THE VILLAS AT CLAREMONT RANCH

STREET IMPROVEMENTS PLANS

THE VILLAS AT CLAREMONT RANCH

STORM SEWER PLANS

THE VILLAS AT CLAREMONT RANCH		DRAWN BY: SLP
POND DETAIL SHEET		SCALE: N/A DATE: 07/29/22
16-102	JOB NUMBER	SHEET
5 OF 5	16-102	5 OF 5

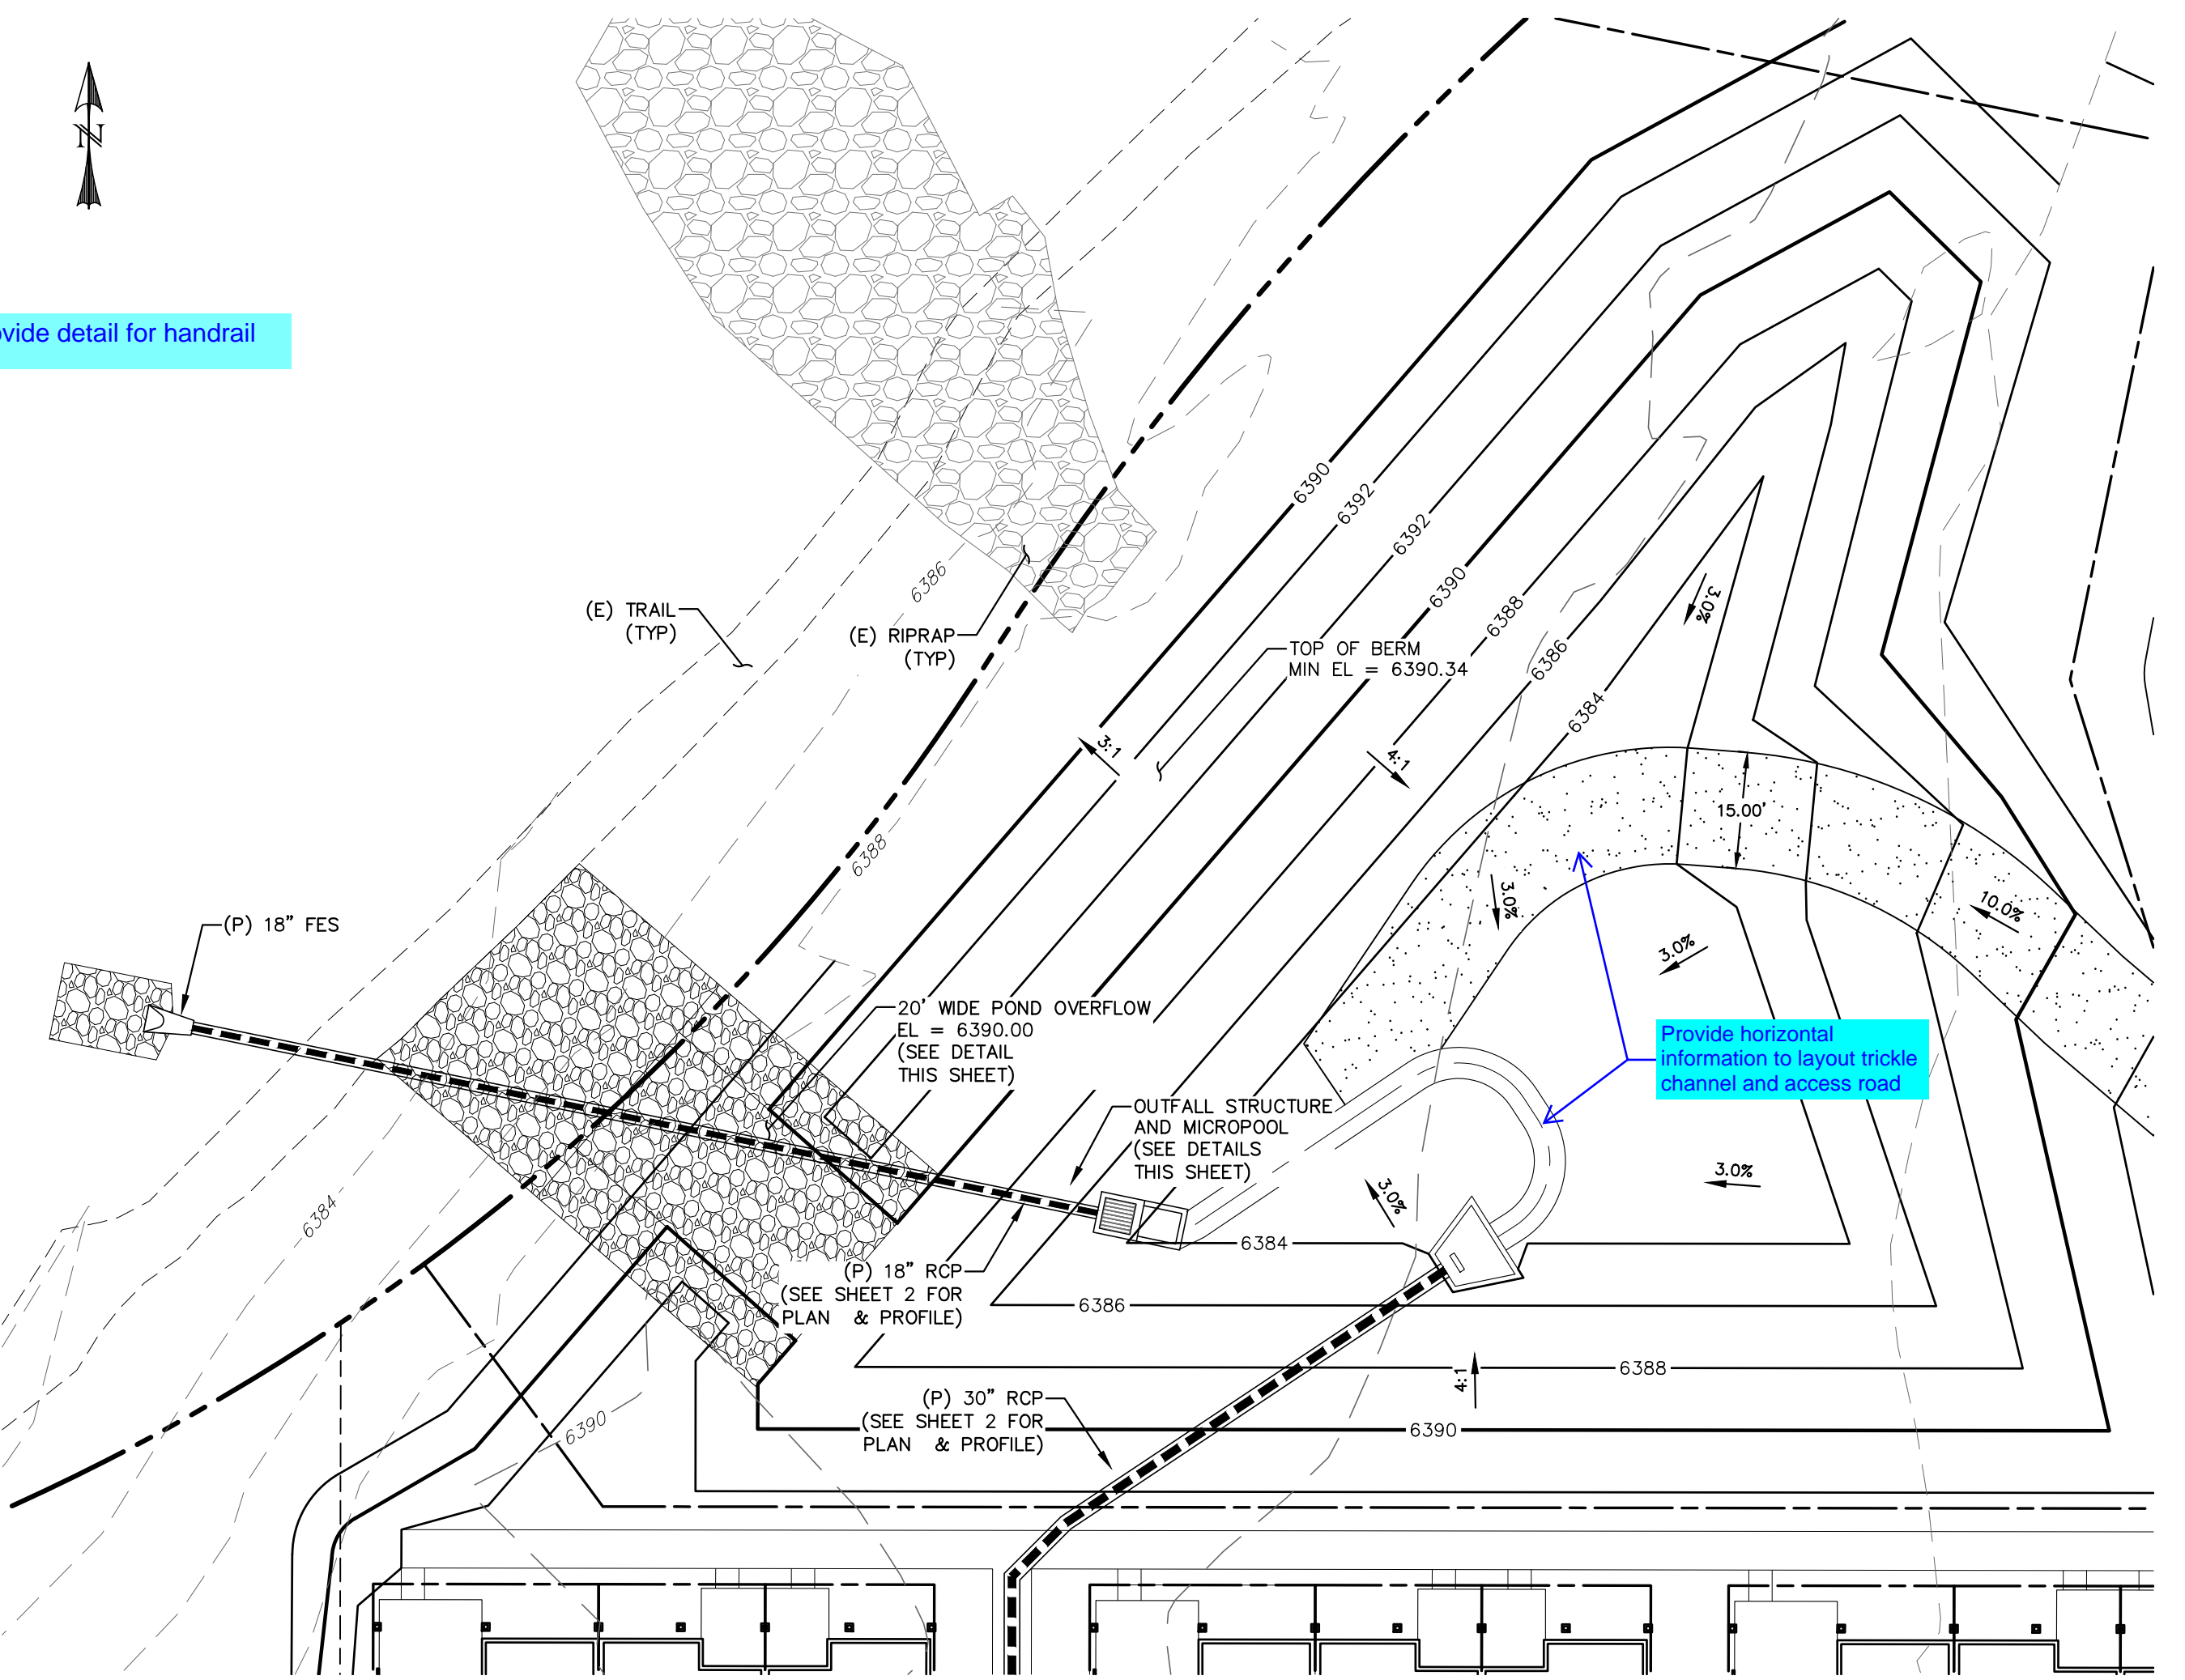
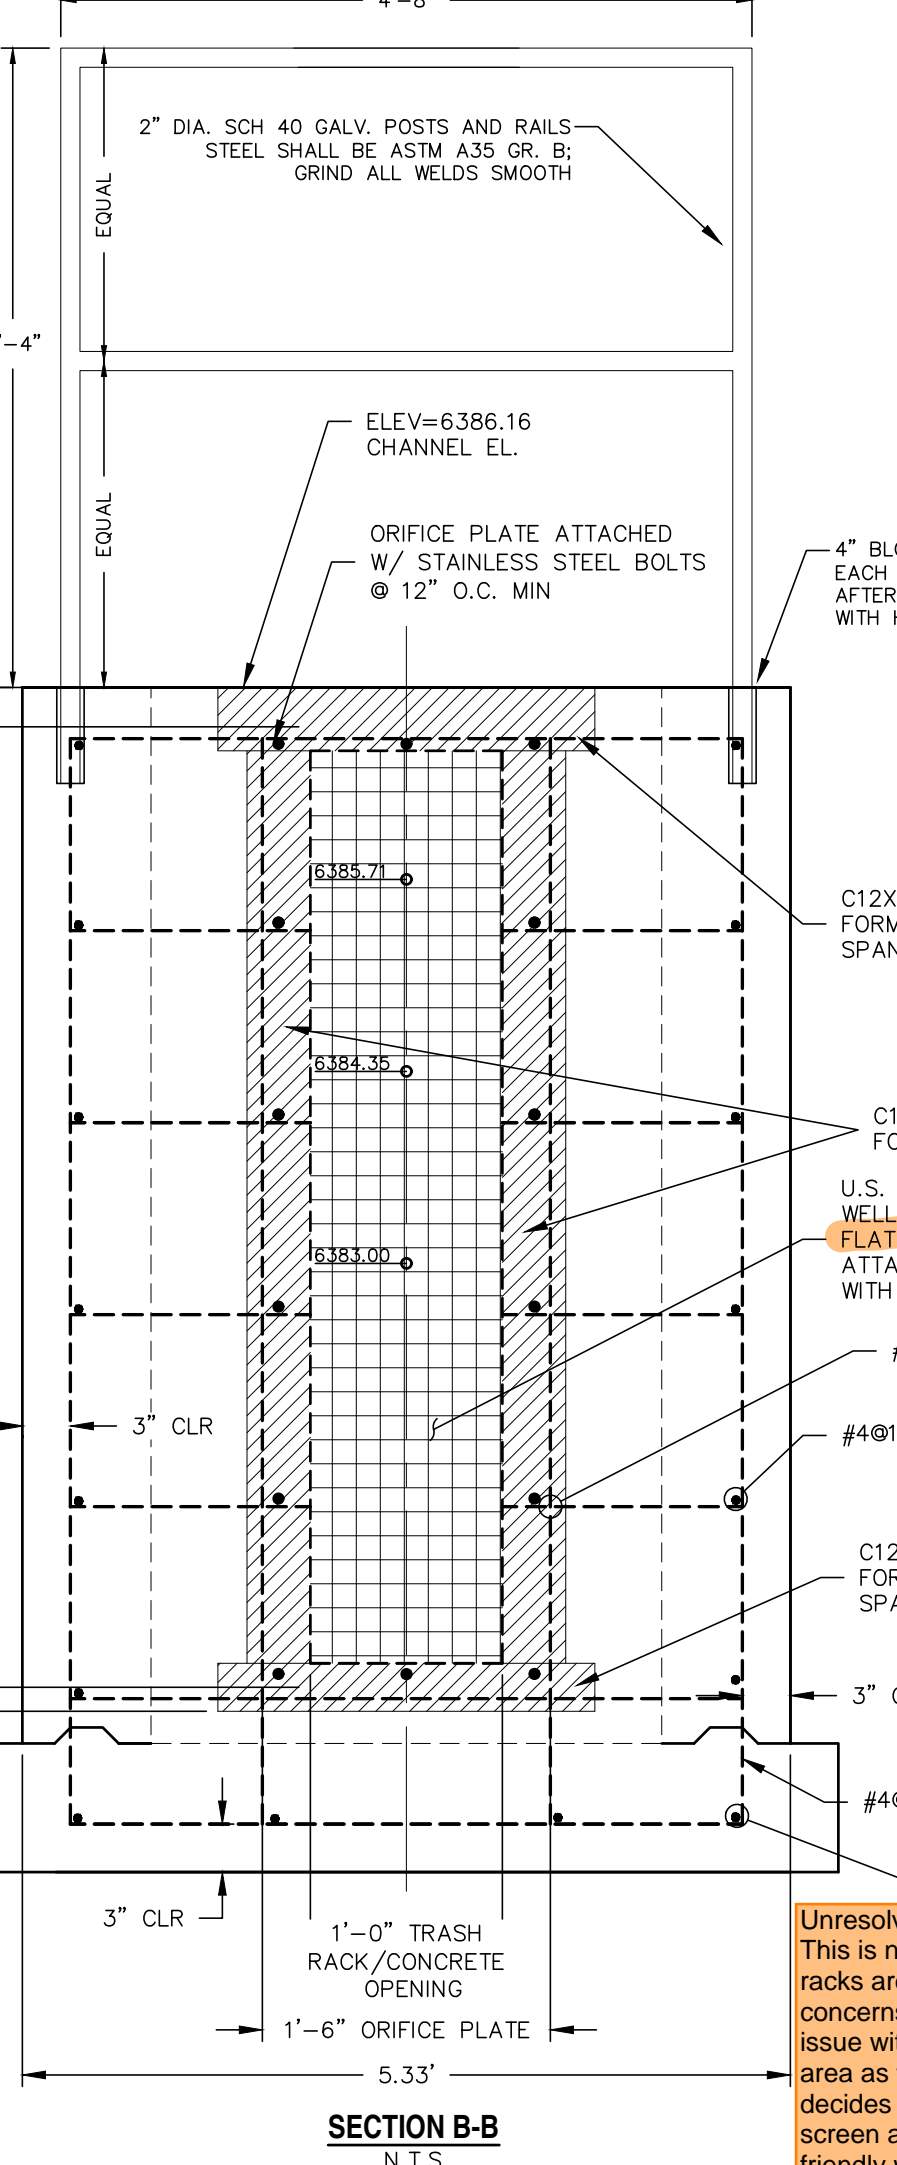
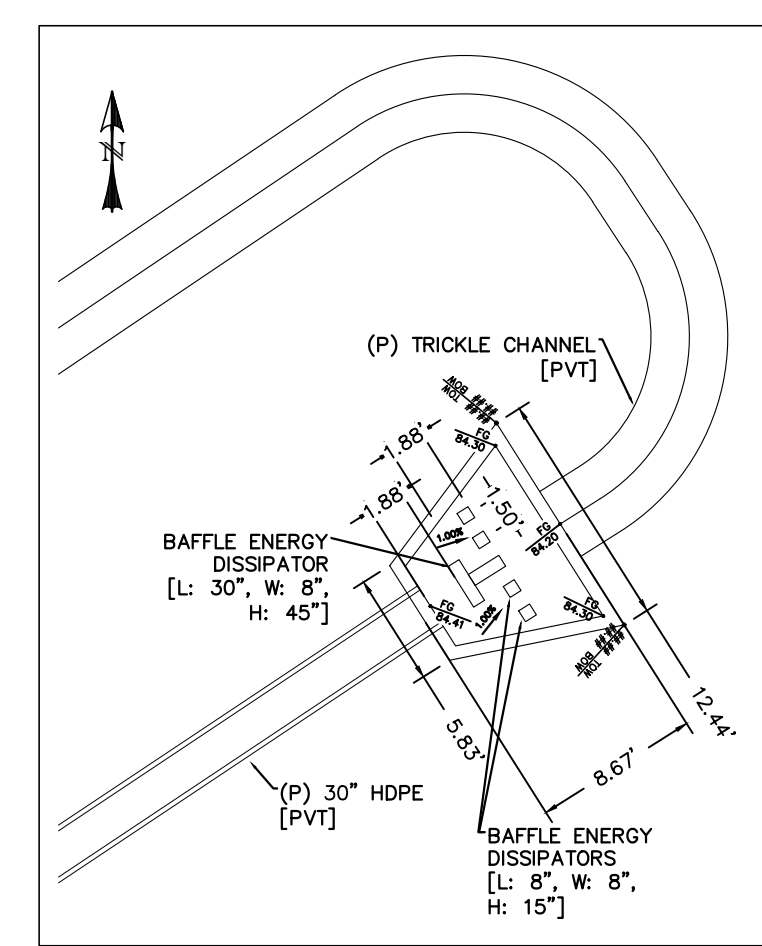
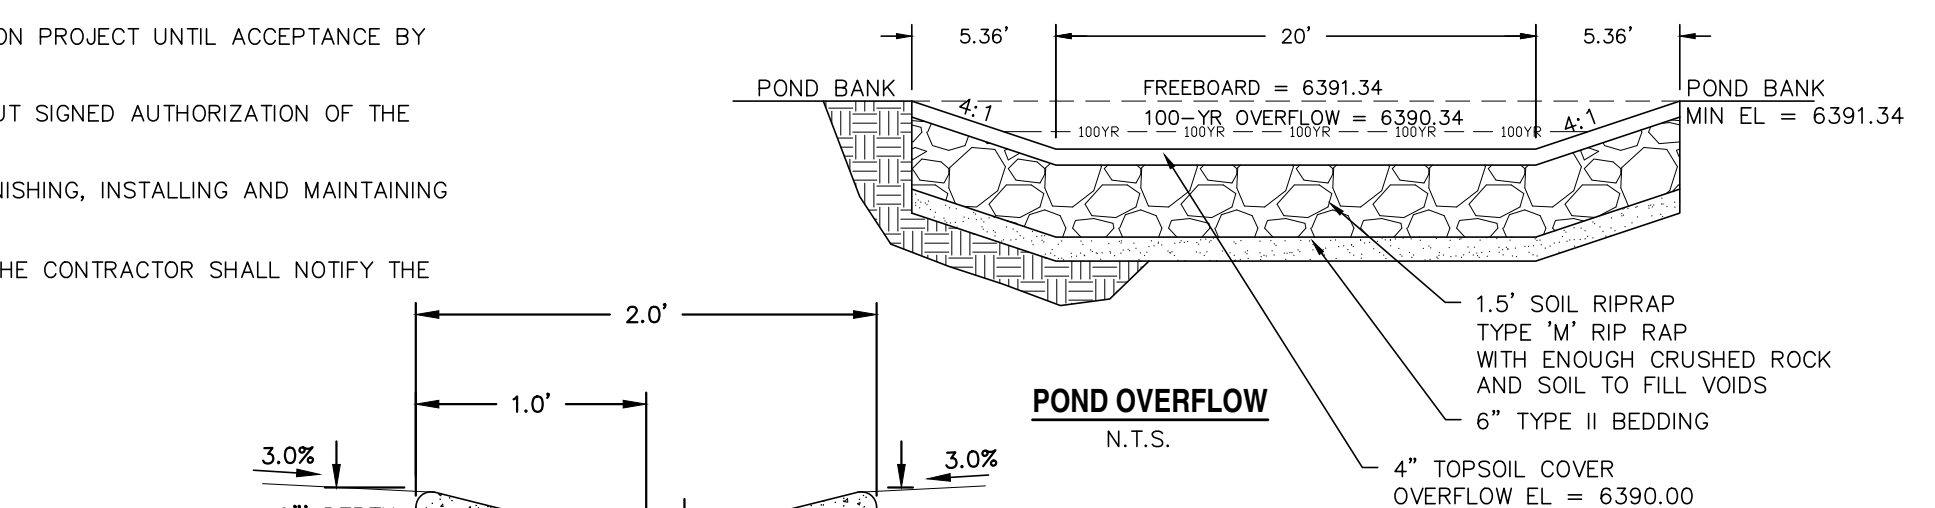
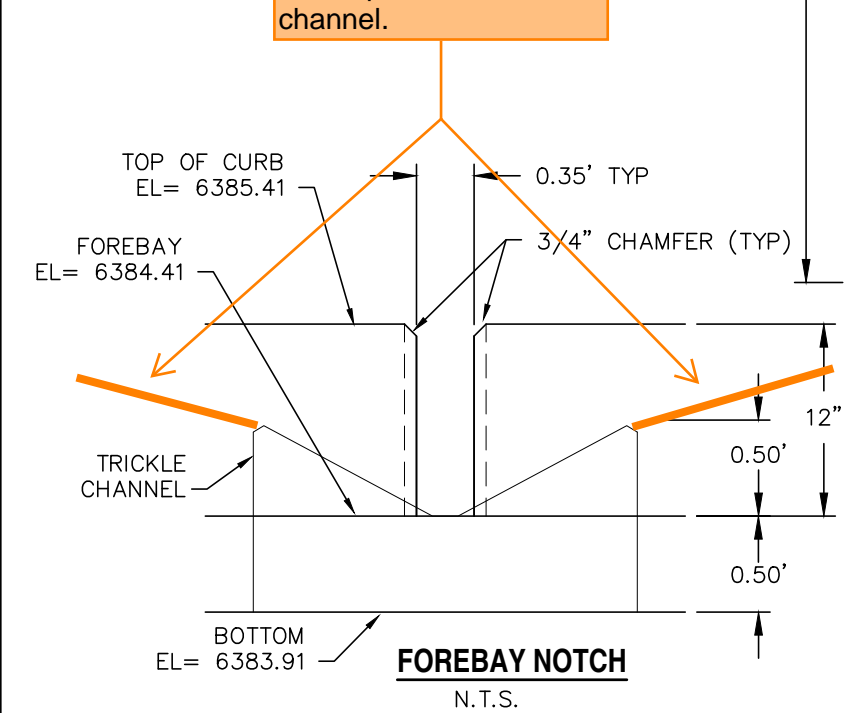
provide detail for handrail

Provide horizontal information to layout trickle channel and access road

Show how pond bottom ties into top of trickle channel curb with min 3% slope towards channel.

Unresolved comment.
This is not an approved alternative, please remove. Diamond plate trash racks are not an equivalent replacement to those in our criteria. We have concerns that the diamond plate is going to be a constant maintenance issue with clogging. Diamonds plates may have the same percent open area as those shown in our criteria but this isn't the only criteria that decides equivalency with the ones specified out in our criteria. The well screen and bar grates in our criteria are designed to be maintenance friendly whereas the diamond plate will clog more often.

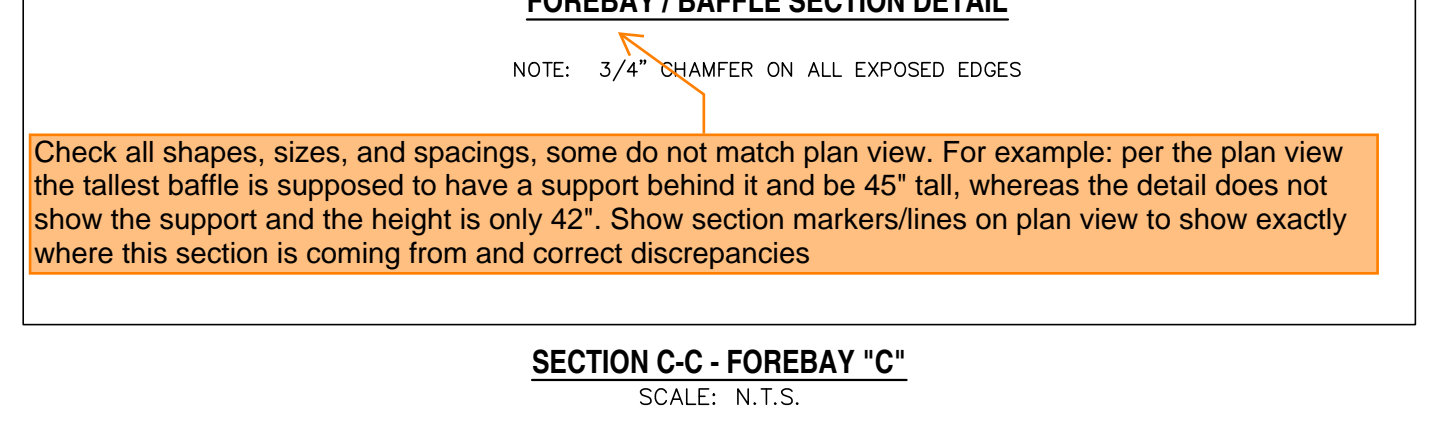
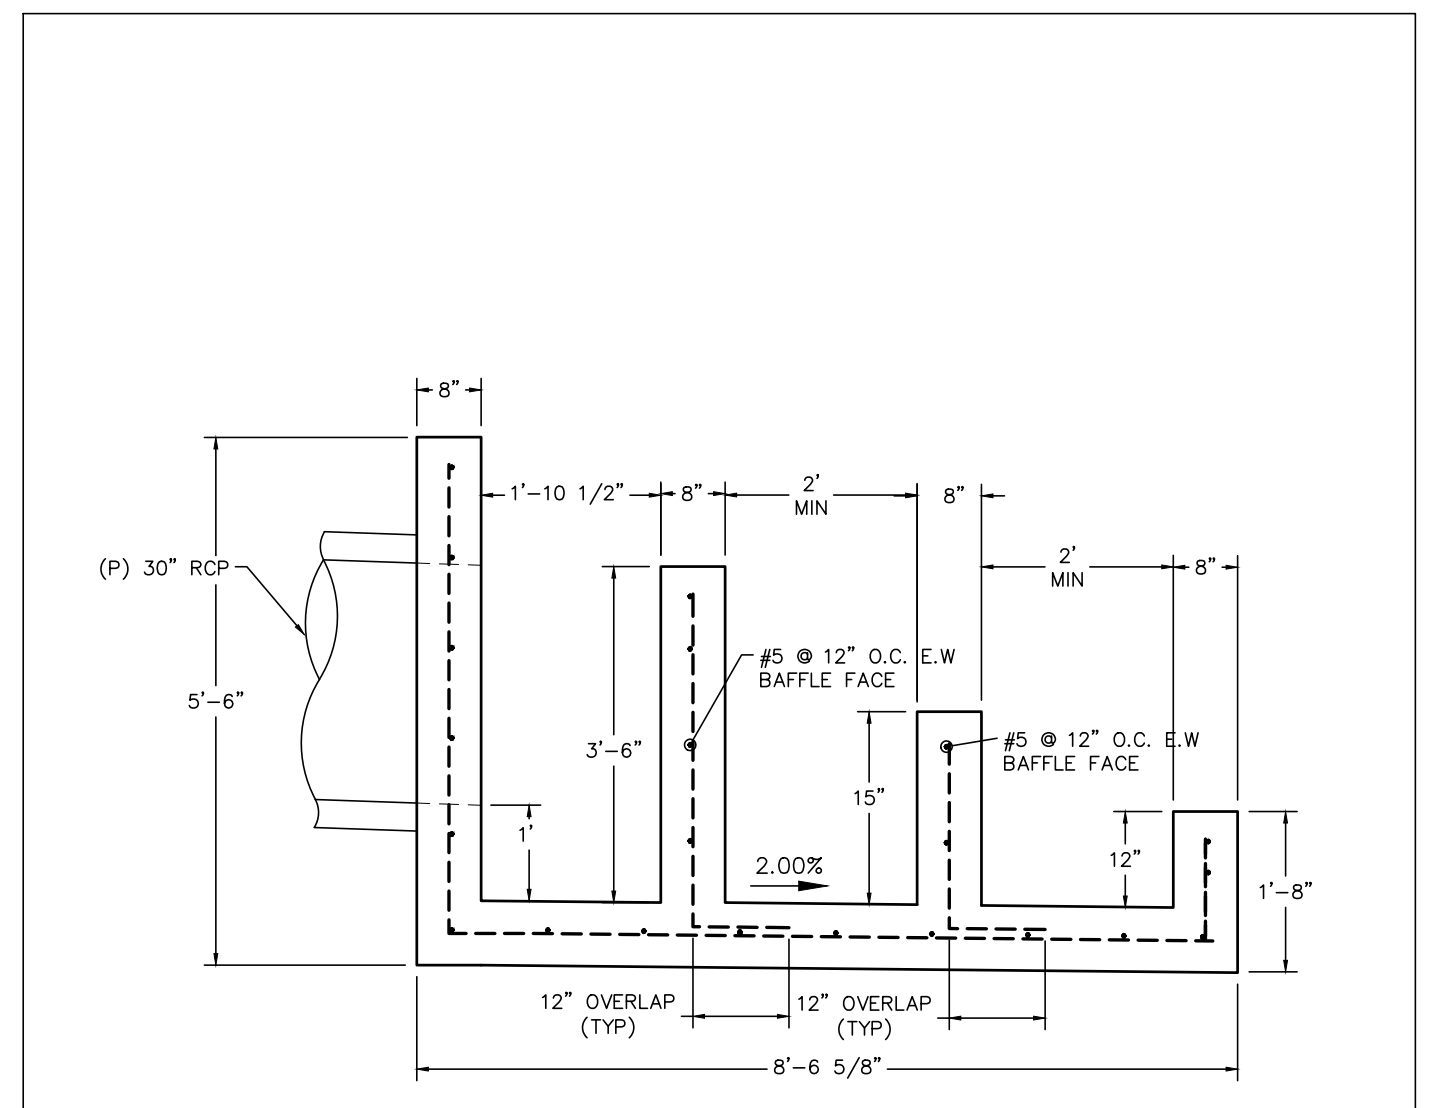
Check all shapes, sizes, and spacings, some do not match plan view. For example: per the plan view the tallest baffle is supposed to have a support behind it and be 45" tall, whereas the detail does not show the support and the height is only 42". Show section markers/lines on plan view to show exactly where this section is coming from and correct discrepancies
